# Variance Request Form

Variance: 026  
Request No.: Rev 0  
Date Submit: 10/11/2012  
Date Approval Needed: 10/15/2012  
Date Agency Received: \_\_\_\_\_  
Agency Approval Reference No.: \_\_\_\_\_

# OCOTILLO WIND PROJECT: IMPERIAL COUNTY, CALIFORNIA

## VARIANCE 26 - OCTOBER 10, 2012

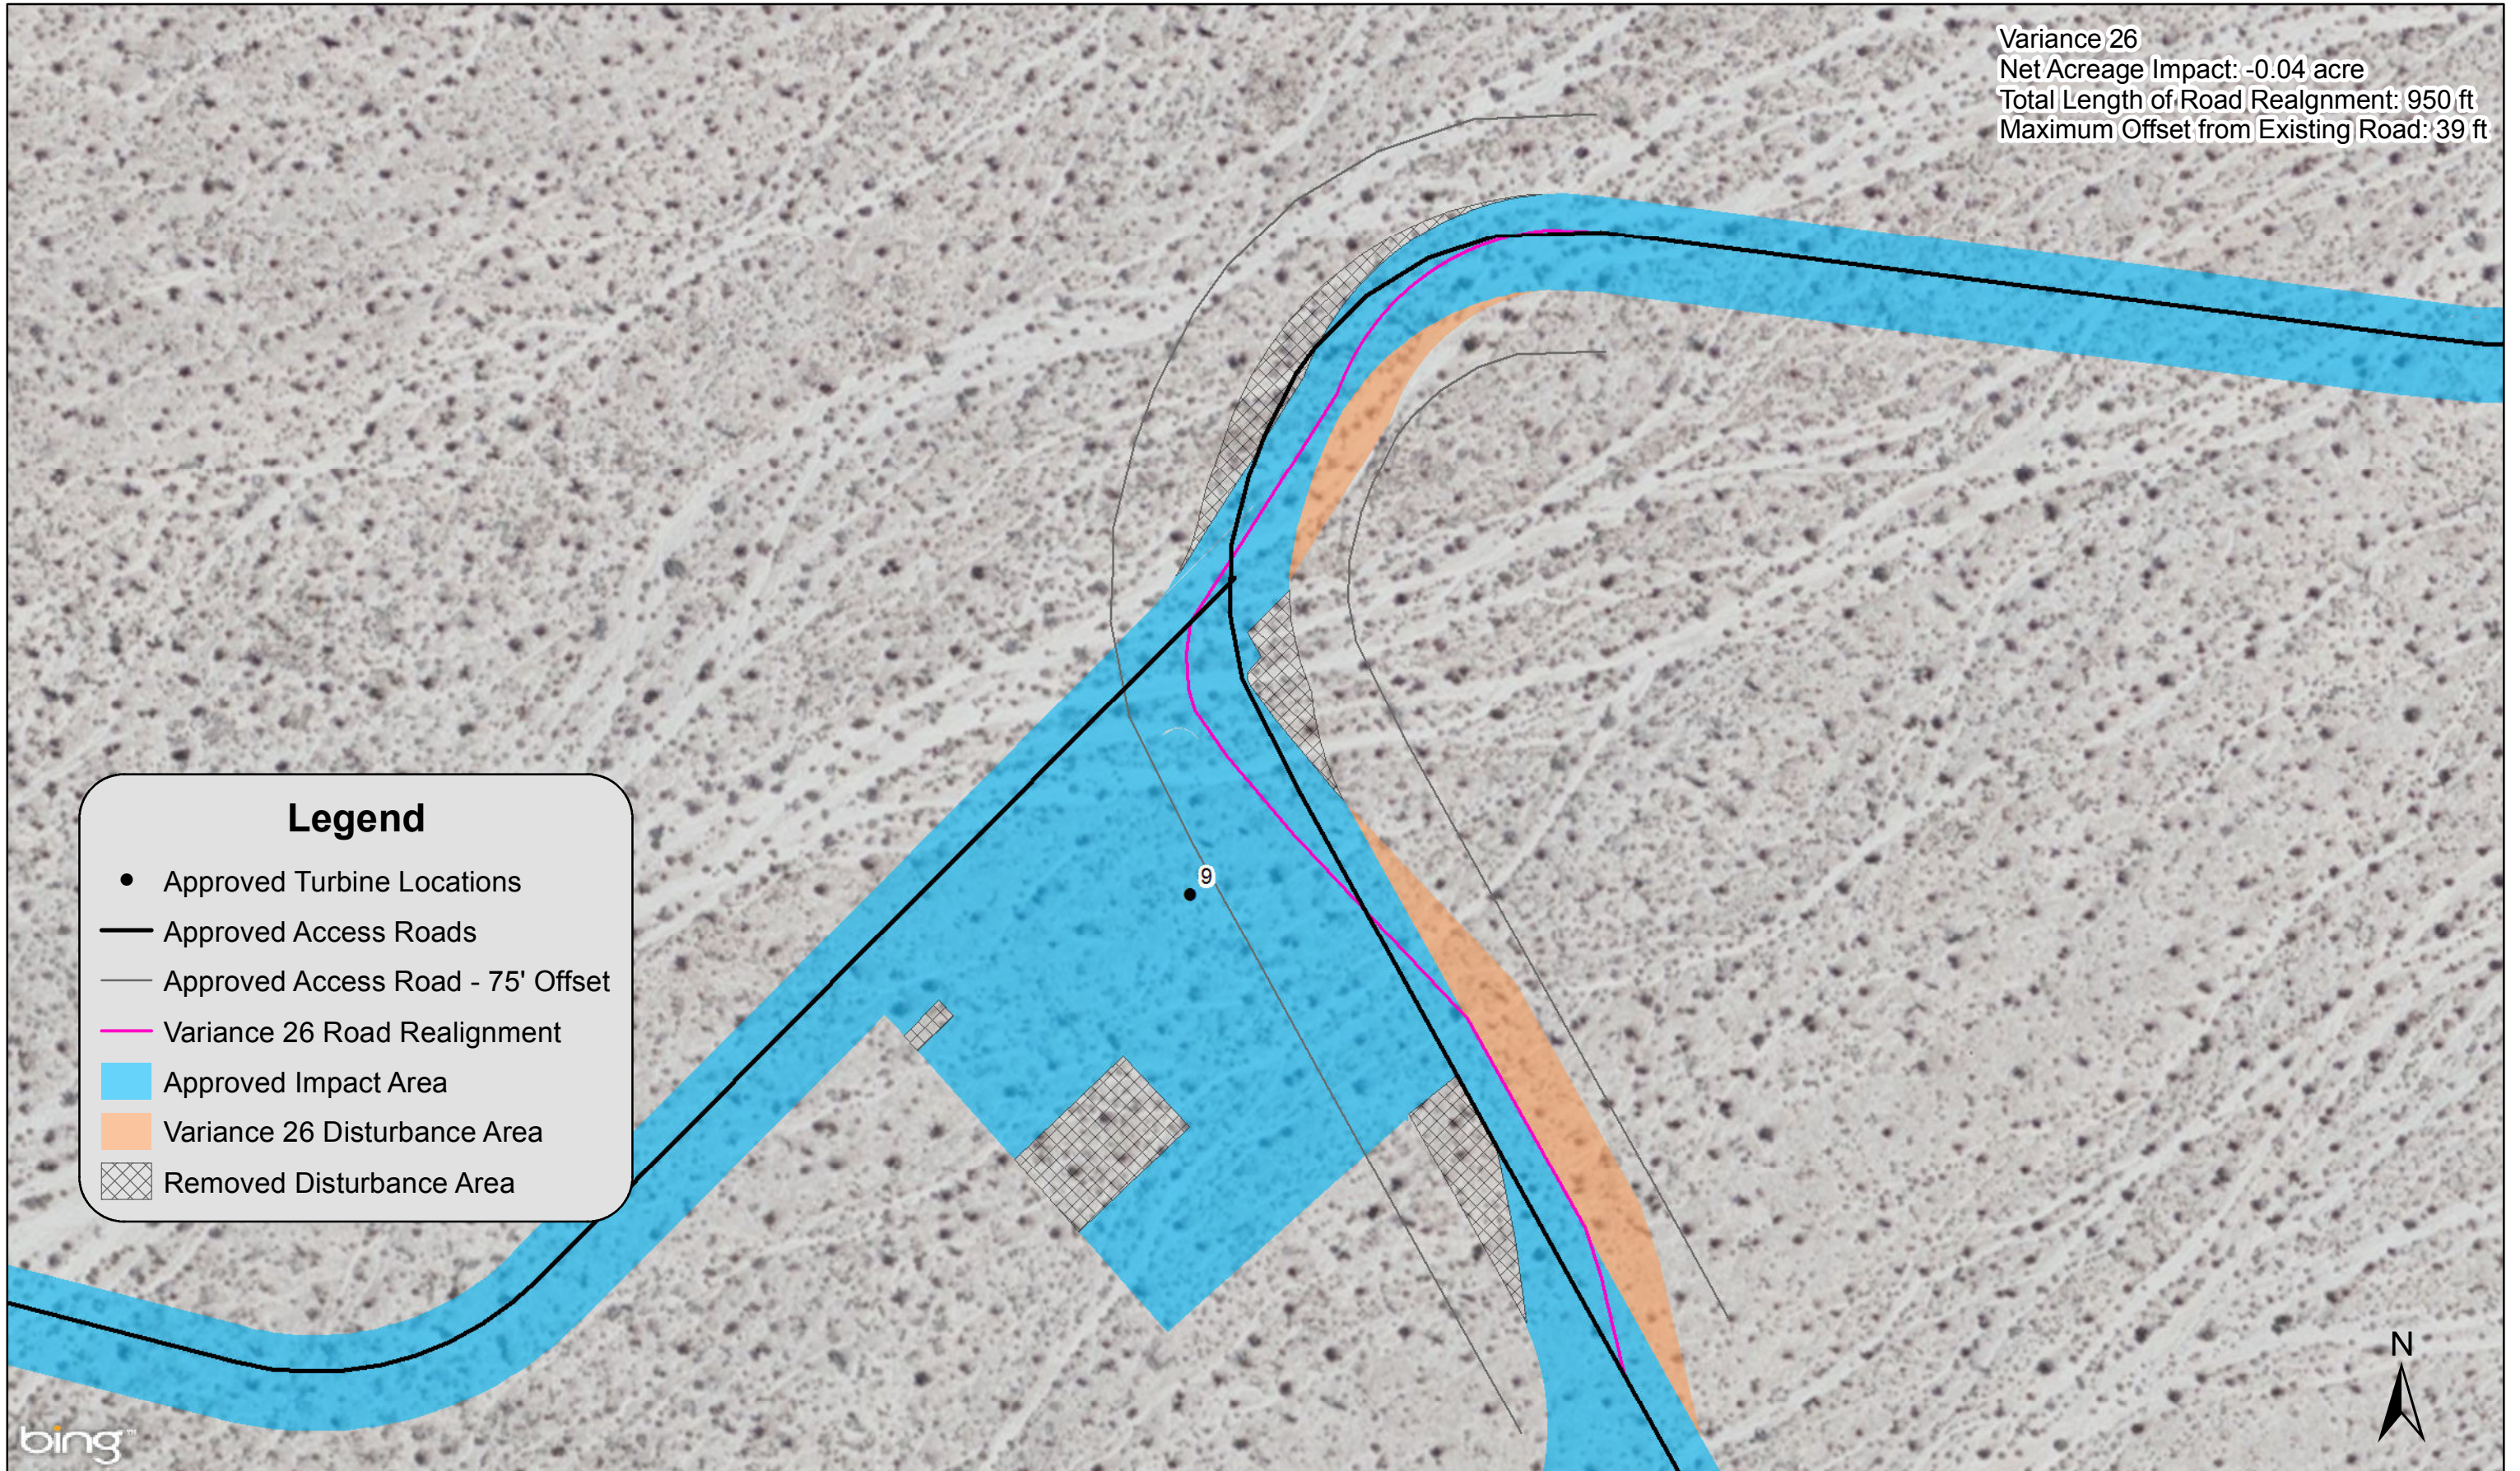
Variance 026 includes modifications to the access road and collection circuit corridor leading into Turbines 9 and 10 (see map attachment). The total length of the access road and collection circuit corridor realignment towards Turbines 9 and 10 is 950 feet with a maximum offset of 39 feet from the currently approved corridor alignment.

Variance 26  
Net Acreage Impact: -0.04 acre  
Total Length of Road Realignment: 950 ft  
Maximum Offset from Existing Road: 39 ft
